**FUTURE MELBOURNE (PLANNING)
COMMITTEE REPORT**

**APPLICATION FOR PLANNING PERMIT: TP-2010-413,
279 FLEMINGTON ROAD, NORTH MELBOURNE**

5 October 2010

DELEGATED PLANNING APPLICATION REPORT

DRAWING
PROPOSED BASEMENT PLAN

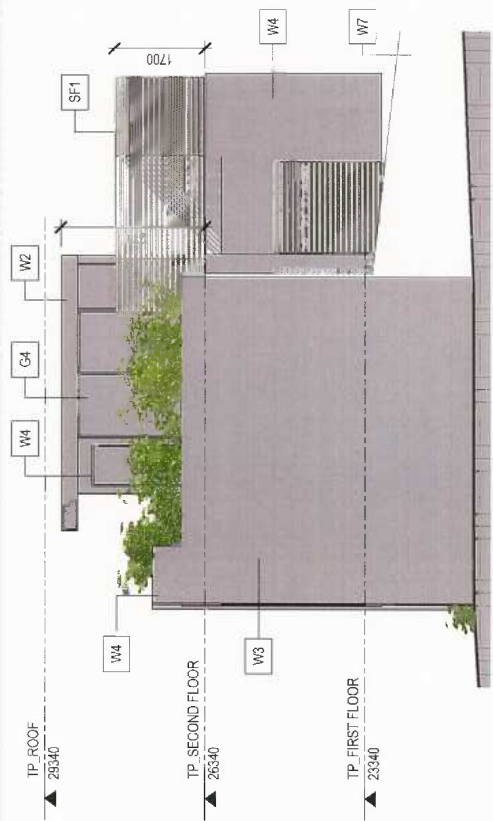
Vehicle access is proposed via an existing crossover, which is to be widened. The plans do not adequately detail the crossover width/location, nor show existing kerb alignment along Dryburgh Street. A plan showing both the proposed access/kerb line information must be provided.

A roller shutter door is proposed at the top of the ramp with a 4.5m opening (plans are not to scale). The top section of the ramp is 5m wide with a grade of 1:20, 5.4m into the site. The next section of ramp is flat, bending acutely and narrowing to 2.8m. Following the short/flat section, the main part of the ramp has 1:5 grade with 1:7 transitions at top/bottom, retaining 2.8m width between walls. While individual aspects of the ramp could be made to comply with some requirements, the overall ramp design is poor. The ramp enters the property at a high-point of the site, making it overly long and requiring a tight bend. The ramp location/ design is unsatisfactory and a significant redesign of access arrangements is required to provide an appropriate ramp.

The basement must be redesigned to provide an aisle extension.

The applicant should show that the storage unit doors are large enough to provide convenient access/egress for bicycles and that there will still be sufficient room for the storage of other items within the storage cages in addition to bicycle storage.

- p). A plan showing the details of the access/ kerb line.
- q). A minimum basement height clearance of 2.1m including above the ramp.
- r). Details of the storage units, demonstrating that a bicycle can be stored comfortably in this space.

DRAWING
STREETSCAPES

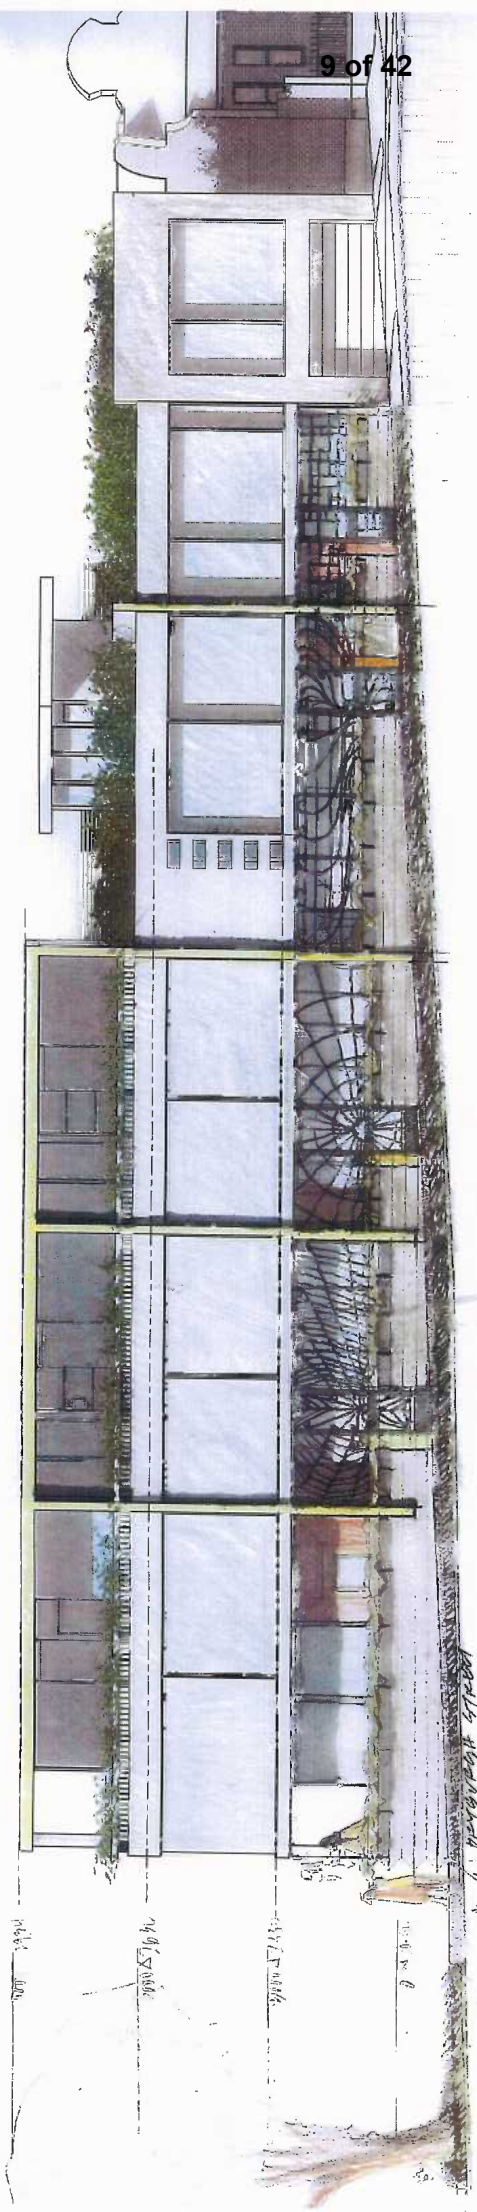
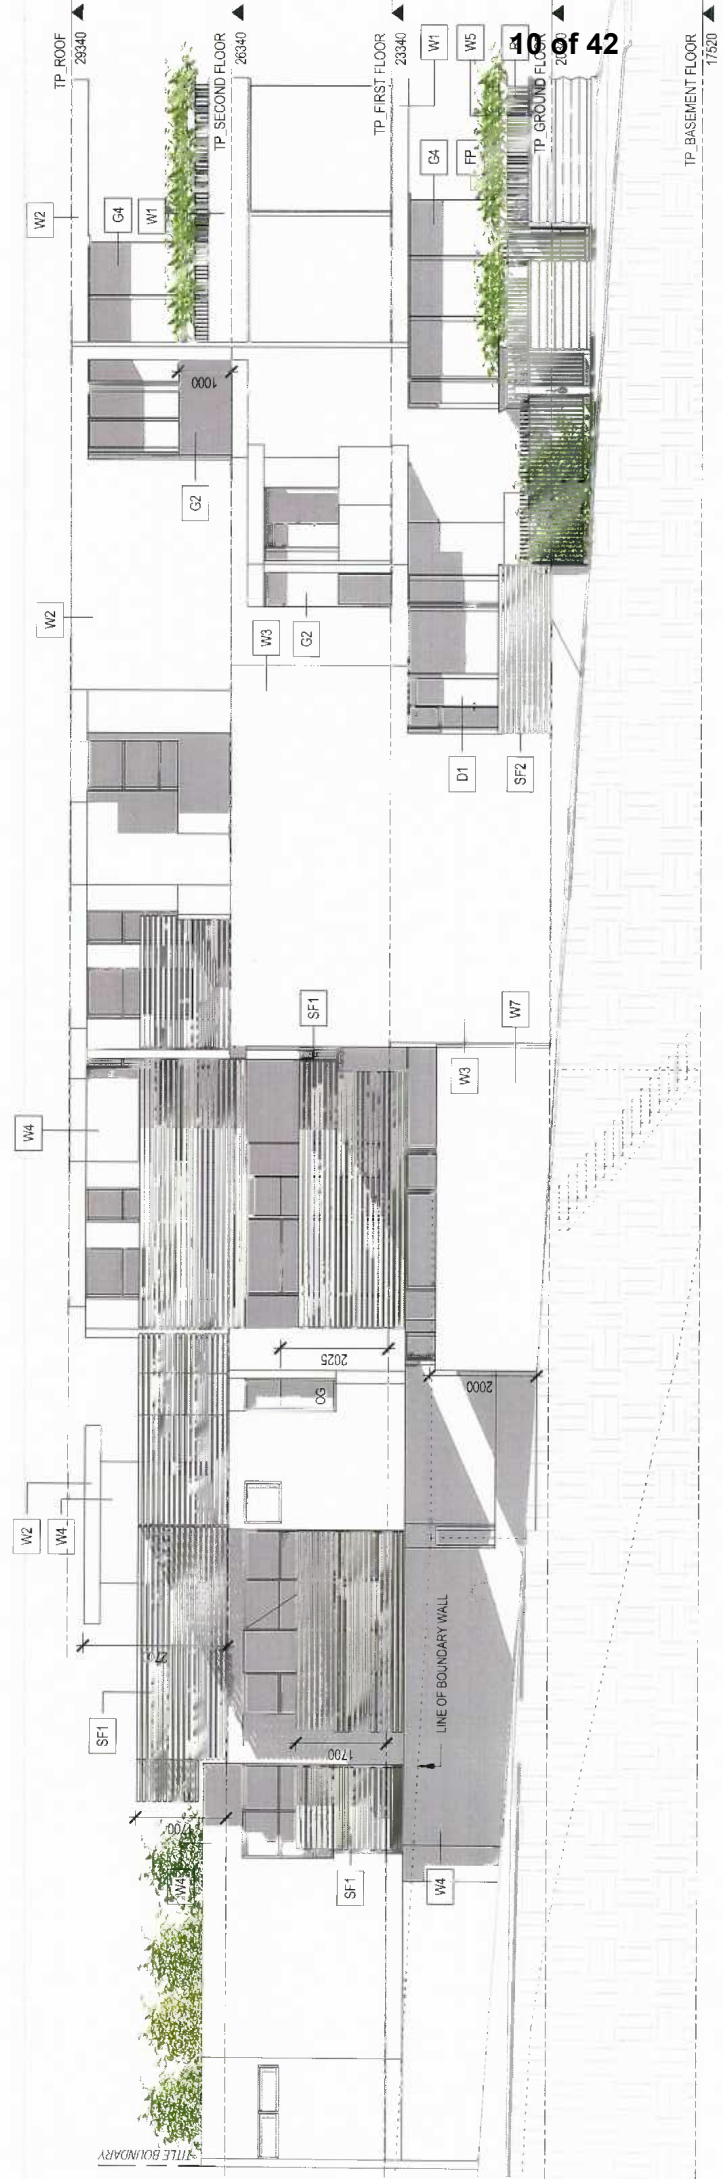
We would request that the Applicant provide a coloured perspective view from the south east and clearly identify the proposed materials on the elevations. This 'pop-out' should present well to the street.

We recommend that the Dryburgh Street elevation be amended (adjacent to the existing terraces at units 5 and 6) to reduce the scale of the façade further and provide a better transition between new and existing built form. This could be achieved by articulating the vehicular entry further.
